工程指示 / 要求簡箋(E.I.)

工程指示編號：EI / 1278 / 19

工程編號：J - 837

工程名稱：觀塘裕民坊

1
5004 TYPICAL MULLION DETAIL
CURTAIN WALL

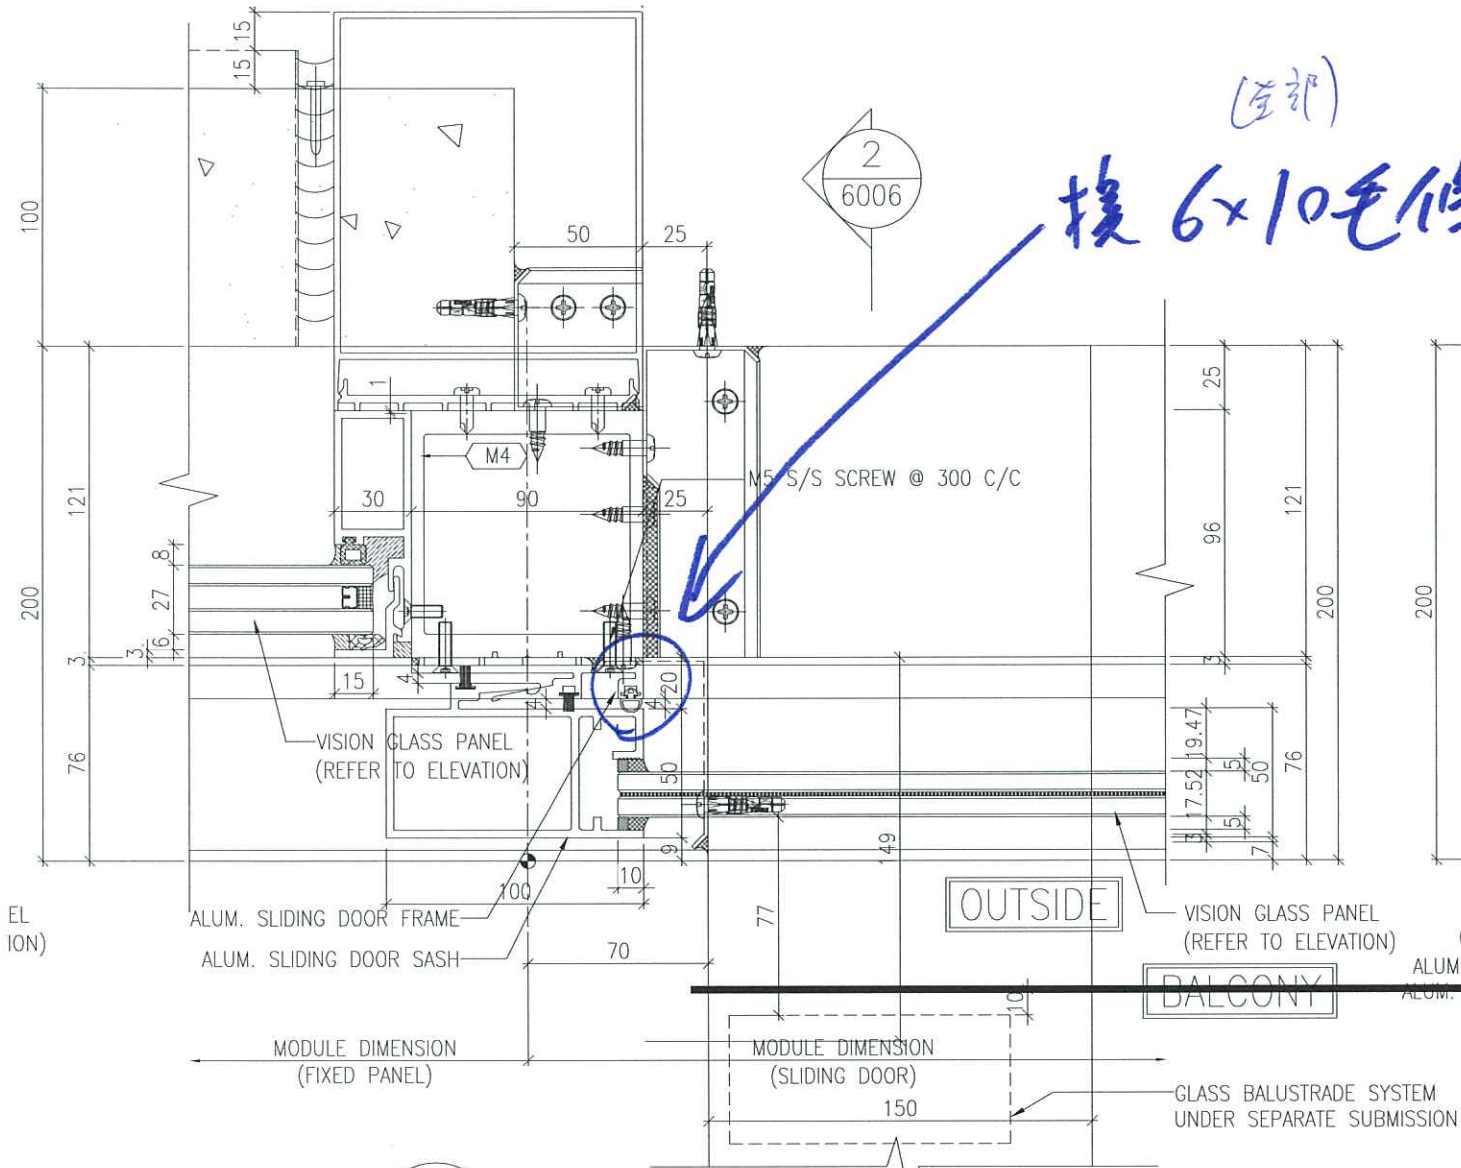
接 6x10毛條

- (1) 因趟門底框位置，按湛哥意見需要更換 6x10mm 毛條才能順趟 + 趟門在(室內方向)
- (2) 趟門頂框，因當時生產完成 M01-M04 時，837-SDG-52 膠條仍未回廠
只有 M05 趟門框有在廠做新膠條，需安排現場更換 M01-M04 膠條
- 謝謝。 請安排分判 / 維修組更換

3 TYPICAL MULLION DETAIL
5004 CURTAIN WALL

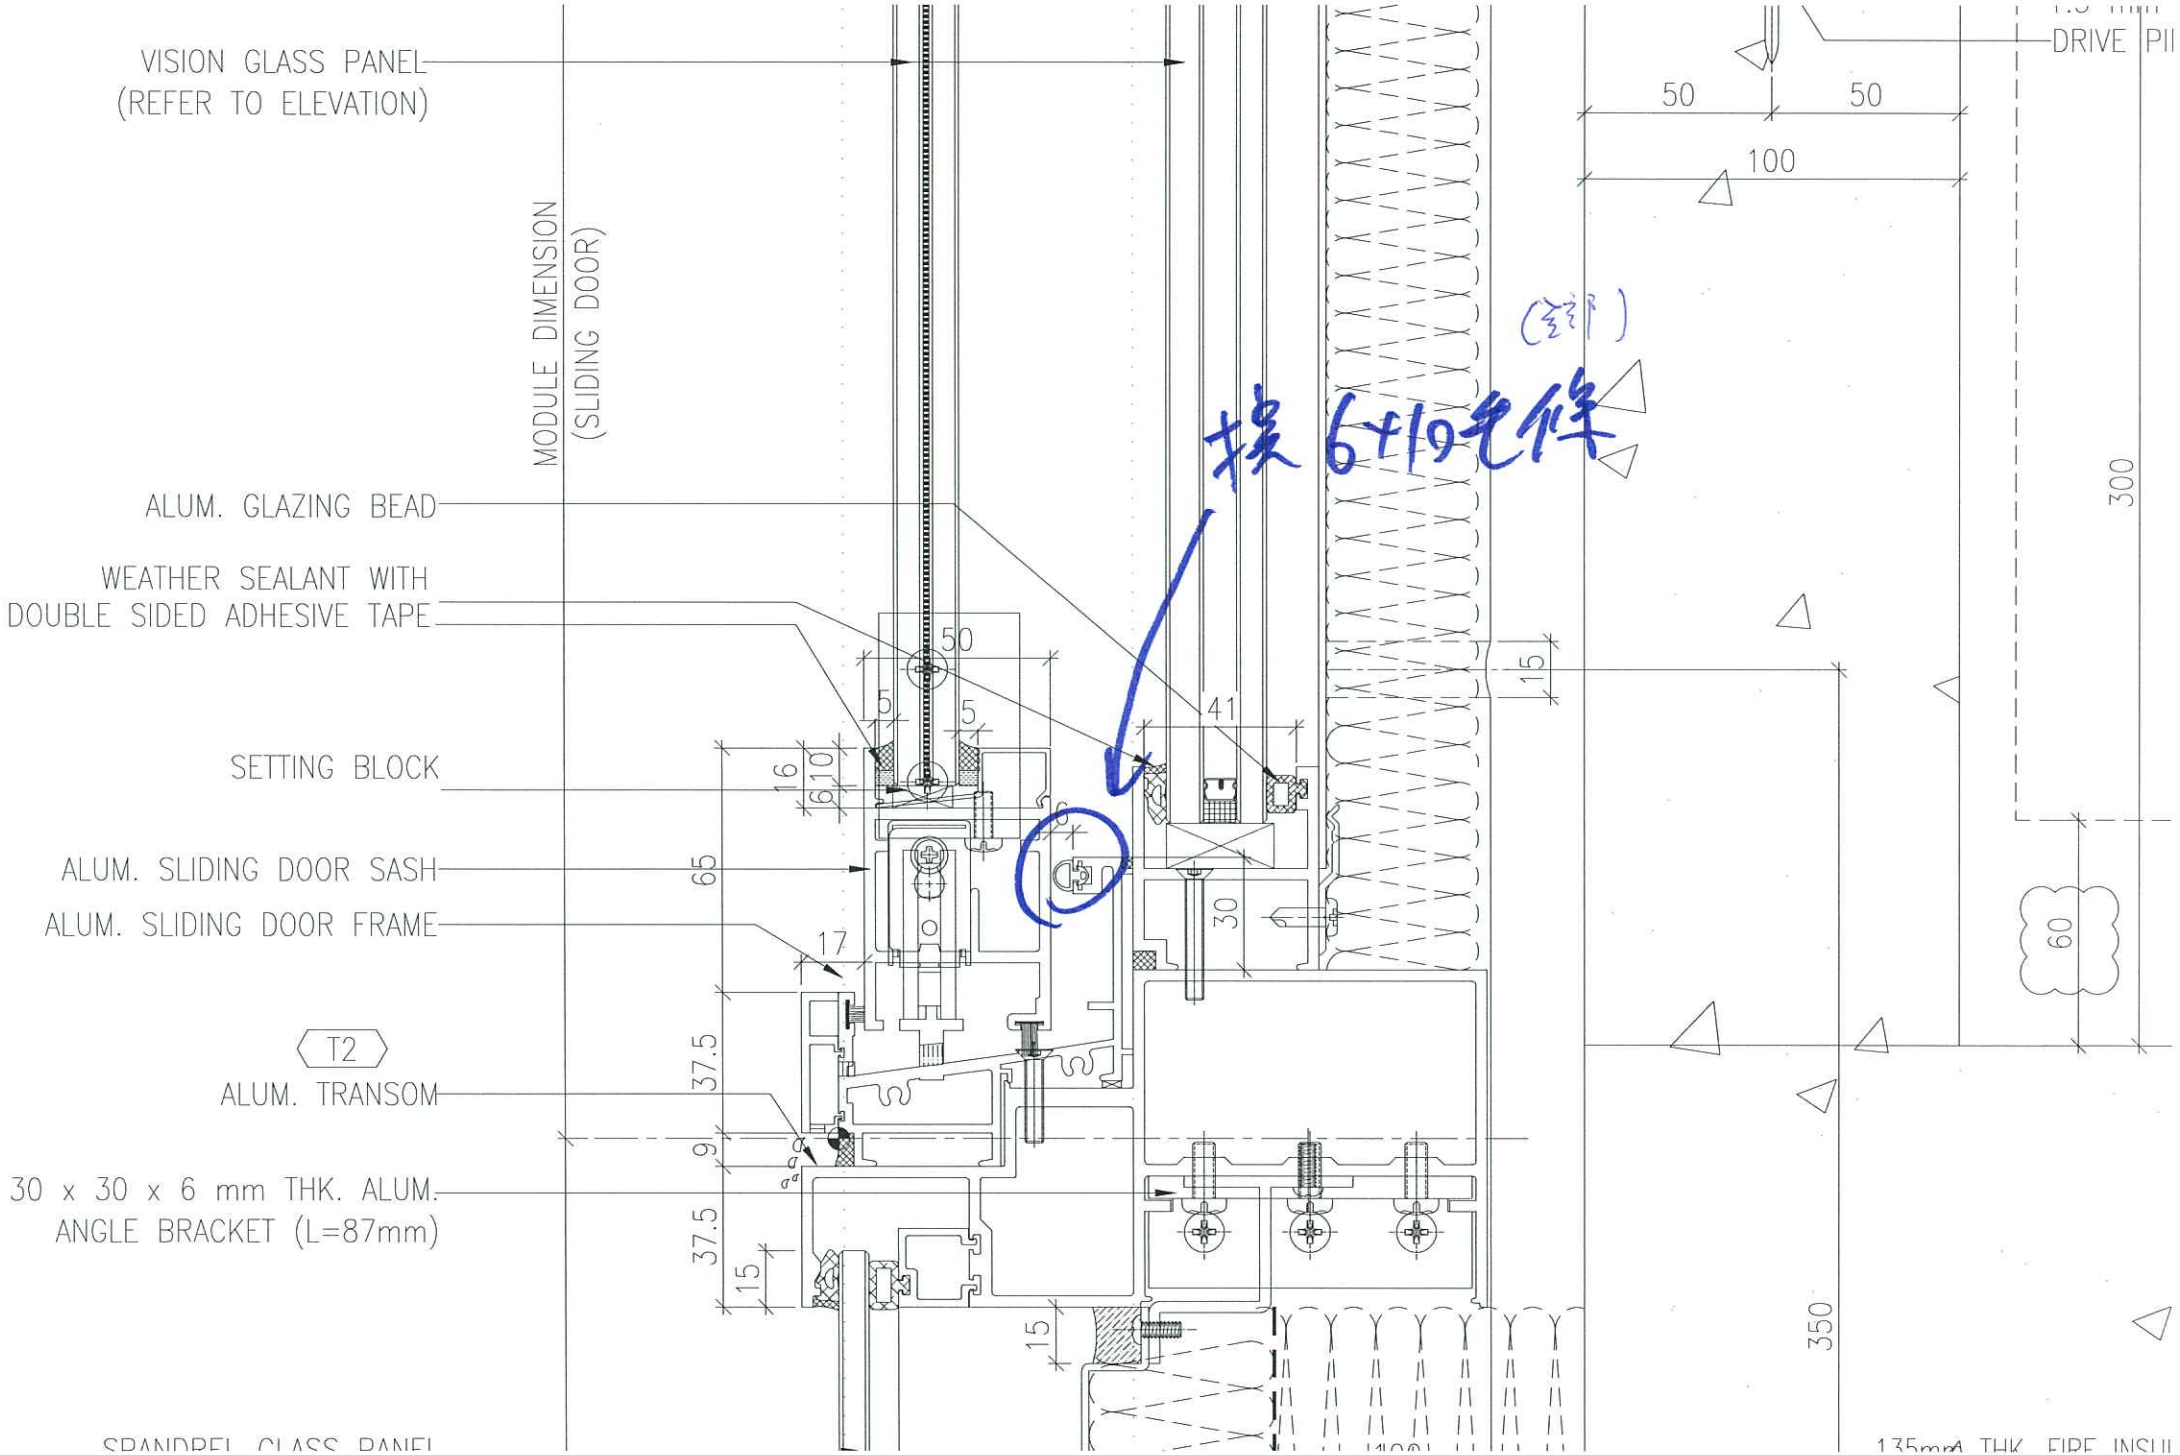
換6+10気條
(全部)
